Date: March 6, 2024
Project: Nicetown Park Renovations
GR Project No. 2009.05

ANSWERS TO QUESTIONS/RFIS:

Acknowledgement of Addendum No. 2

Date: March 1, 2024
Project: Nicetown Park Renovations
GR Project No. 2009.05
To: Robert LaBrum, PHDC
From: Julie Bush, Ground Reconsidered
Distribution: Francesco Cerrai, PPR
Priyanka Malik, PPR

KSE PROJECT NO.	2471-02	DRAWING NO.	C-1.0
DATE	01.19.2024		
SCALE	1" = 30'-0"		
DRAWN BY	KSE		
CHECKED BY	RSB

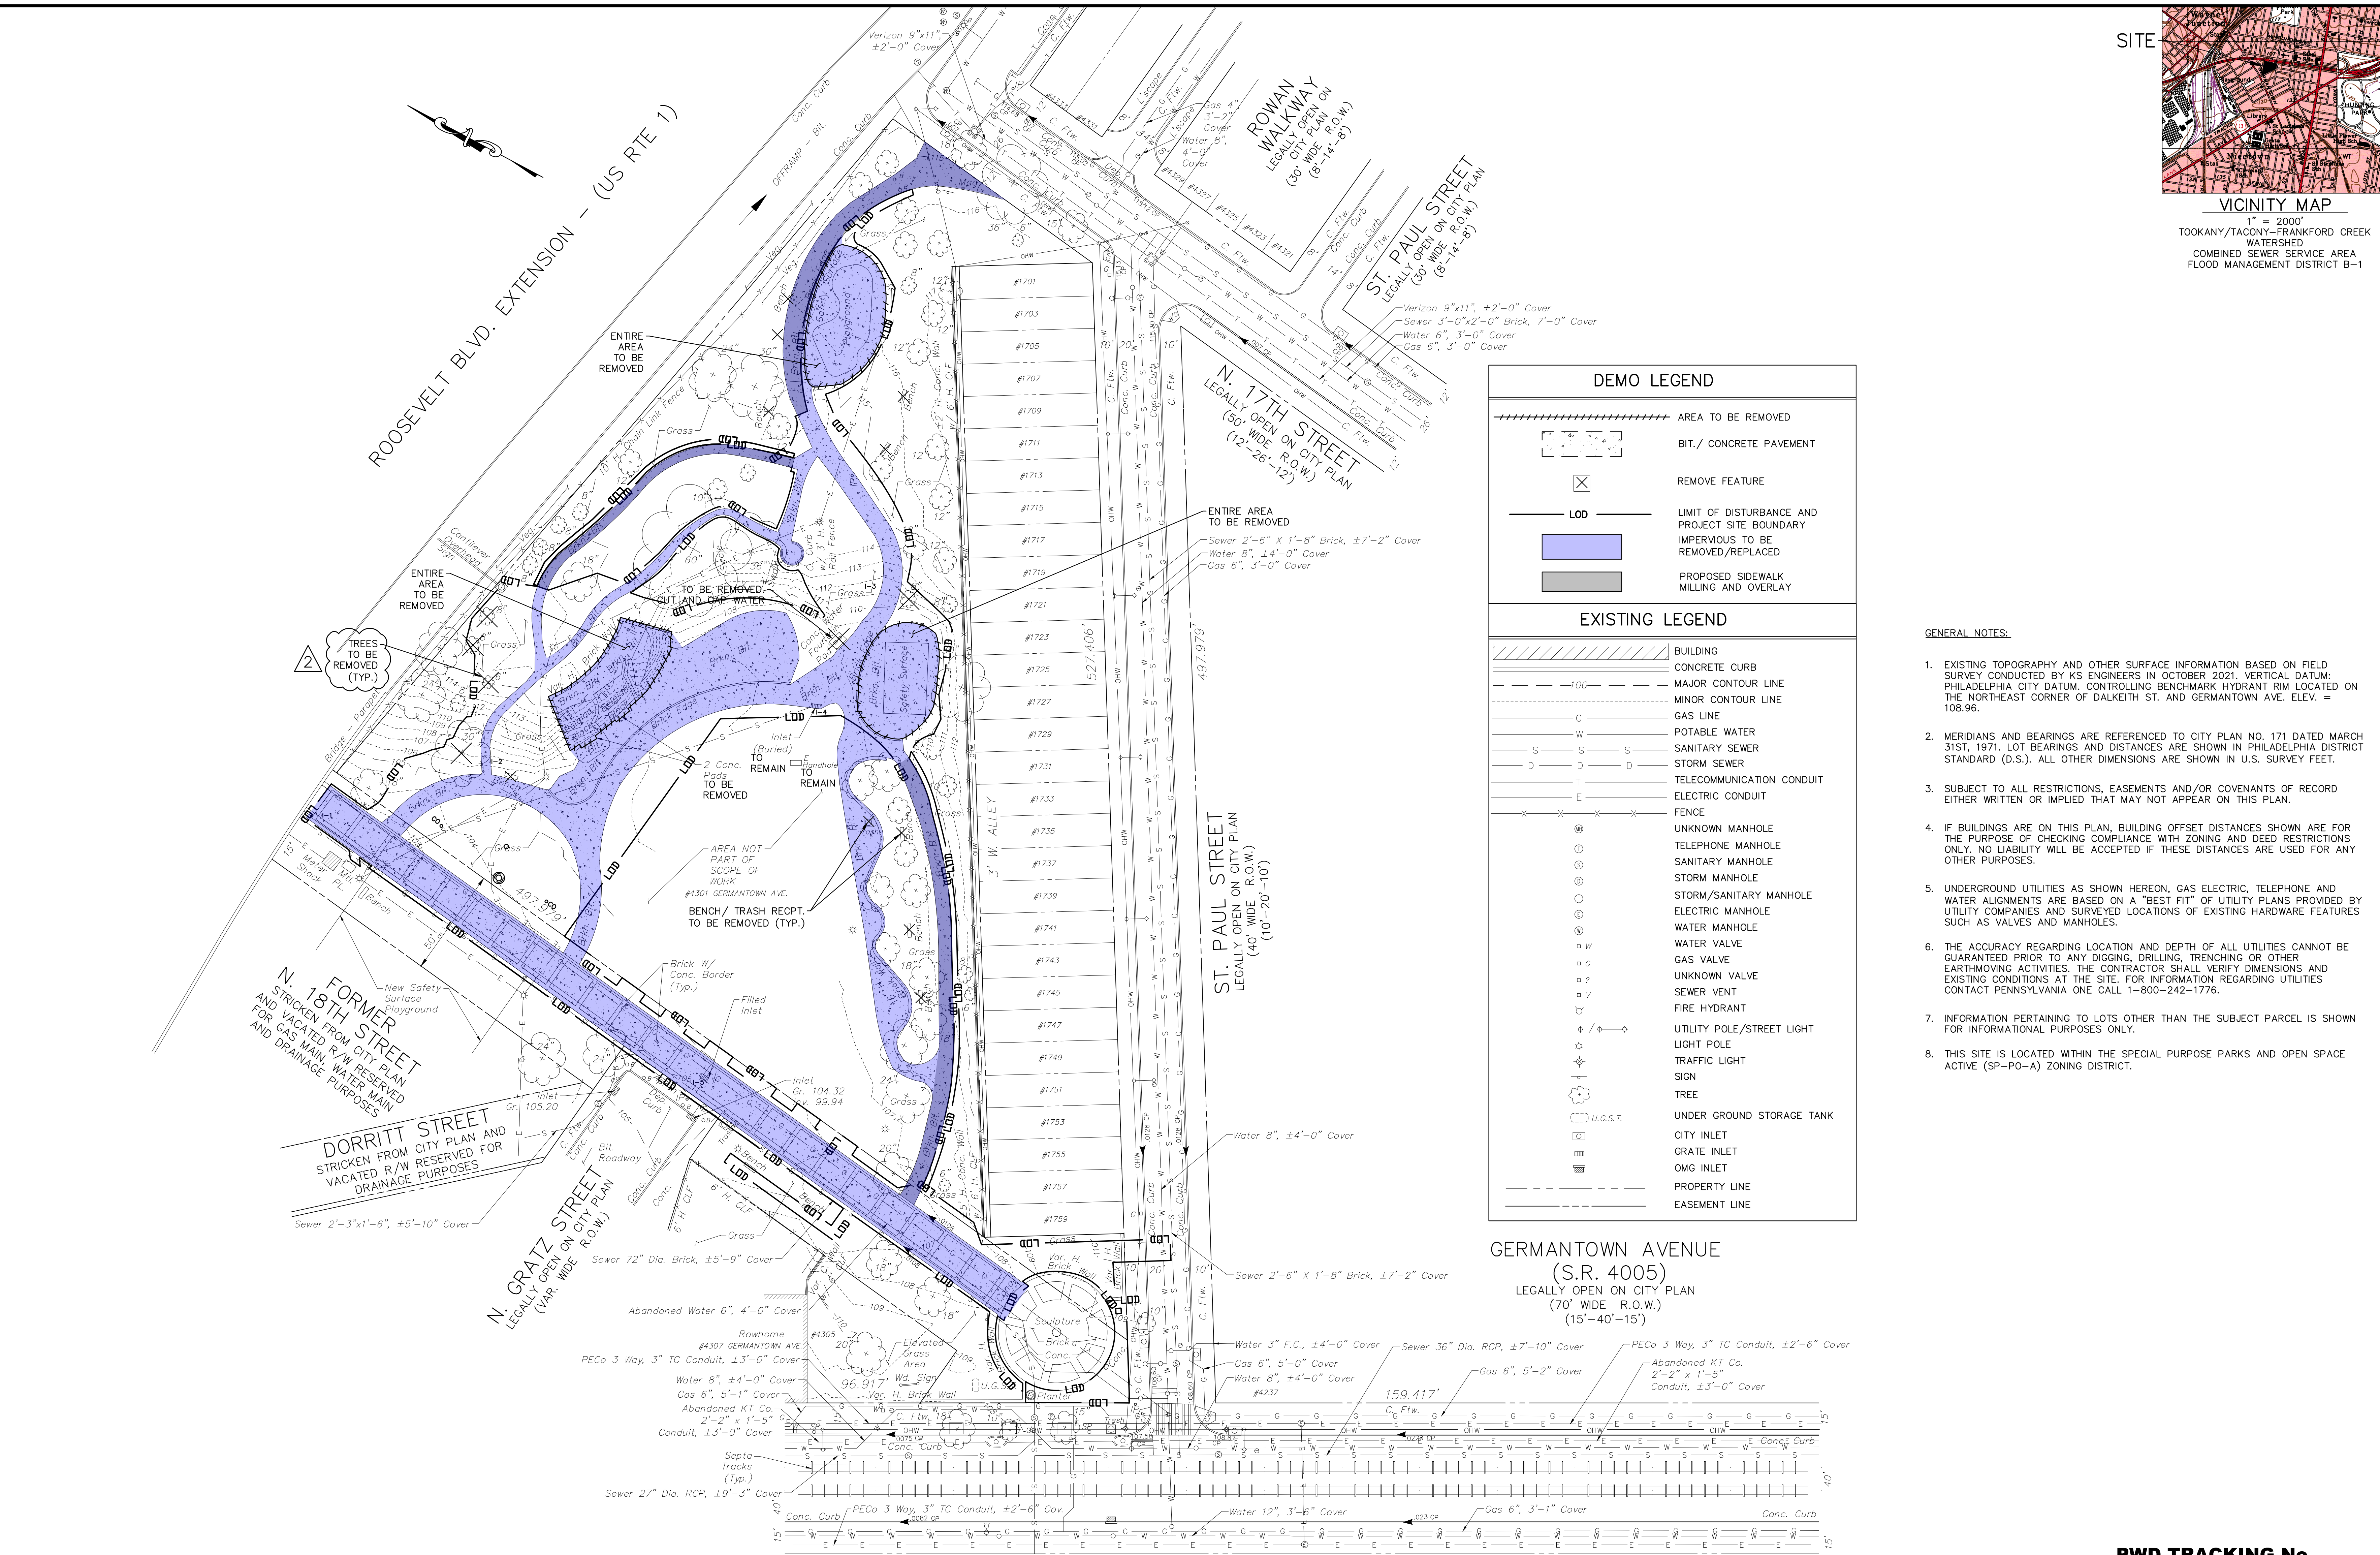
C-1.0 Existing Conditions Plan

- Updated existing tree removals to match L-1.0

1. The tree removals on Sheet C-1.0 do not match what is shown on Sheet L-1.0. Which sheet is correct?
 - a. Tree Removals shown on L-1.0 are correct.
2. Demolition Note 1 on Sheet L-1.0 says to excavate under demolished paving a minimum of 24 inches in proposed lawn areas. Detail 2/L-6.4 shows 10 inches of topsoil/compost in lawn areas. Are we to include 24 inches or 10 inches in our bid?

KSE PROJECT NO.	2471-02	DRAWING NO.	C-1.1	
DATE	01.19.2024	SCALE		1" = 30'-0"
DRAWN BY	KSE	CHECKED BY		RSB
CHECKED BY	RSB

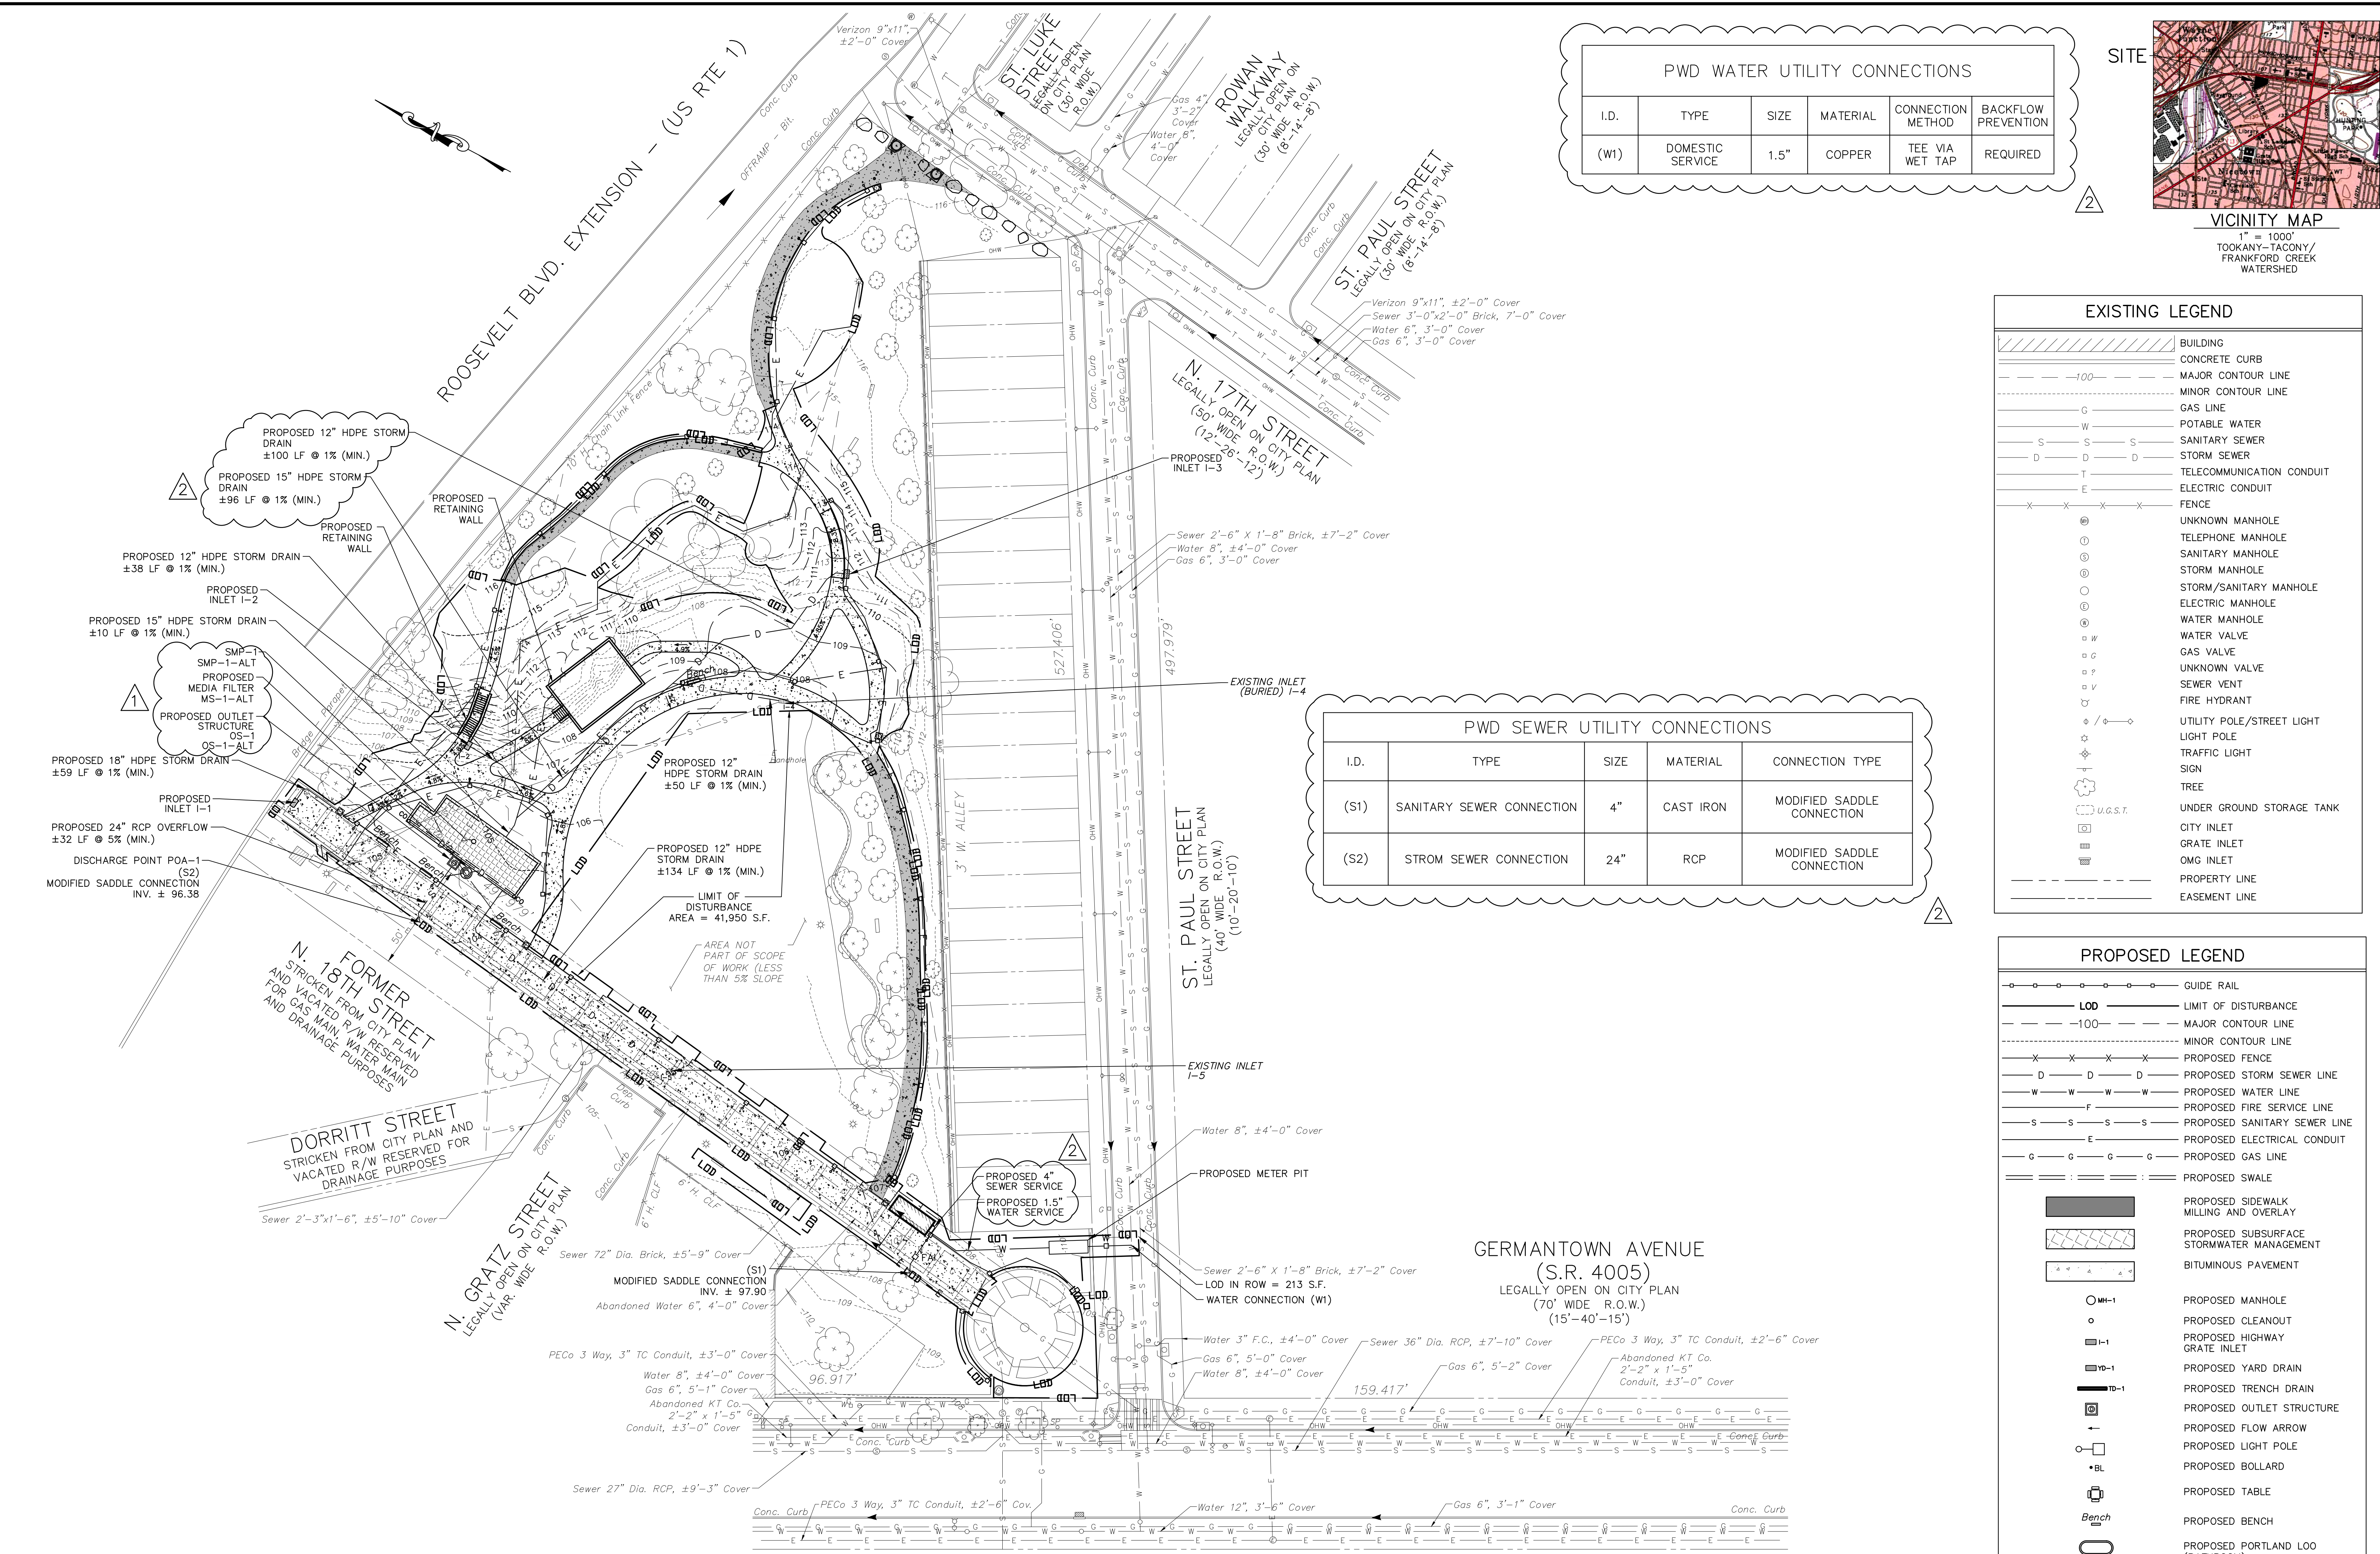
C-1.1 Drainage & Utility Plan

- Updated 196' segment of 12" HDPE storm pipe to a 100' 12" pipe segment and a 96 LF 15" pipe segment for required pipe capacity
- Updated sanitary sewer connection to 4" to match plumbing drawings
- Updated domestic service size and material to 1.5" copper to match plumbing drawings
- Removed floating callout for 120' of 12" pipe from old version of design

7. There is a label for 12" pipe and an arrow pointing to nothing. Assuming this was part of an old design and they missed deleting this note. Please confirm that this 120' of pipe is not in the job. (attachment)

9. Sanitary – Civil plans call for a 5" CIP connection. Plumbing drawings call for 4" pipe. Assuming 5" as it is more detailed. Please confirm.
 - a. There are two (2) water closets, two (2) lavatories and two (2) emergency floor drains, for a total of 10 DFU. A 4" CI pipe will meet the plumbing code requirements. (Reference Table P-709.1 for fixture units and Table 710 for fixture DFU on a drainpipe, new installation).

10. Water – Civils show 1" Ductile (which doesn't exist) assuming they meant 1" Copper. Plumbing shows 1-1/2" Water. Details show a meter pit with a 6" DIP connection. 1. Please confirm we are using 1" Copper and associated meter pit.

- a. The 120' segment of 12" pipe is no longer included in the design.
8. Storm – Plans call for 24" RCP outflow pipe from the control structure. The Utility connection table calls for this to be 15" CIP. I am leaning towards the 24" since the control structure detail calls for a 24" HDPE outflow pipe (Street connections cannot be HDPE so I know that is out). It looks like we are tying into a 72" Brick Sewer, so both options would work. Please confirm size.

- a. Copper Type K for underground is the correct material for plumbing. The GPM is increased due to the addition of lavatories in the proposed pre-fabricated building. Domestic water pipe to be 1-1/2".
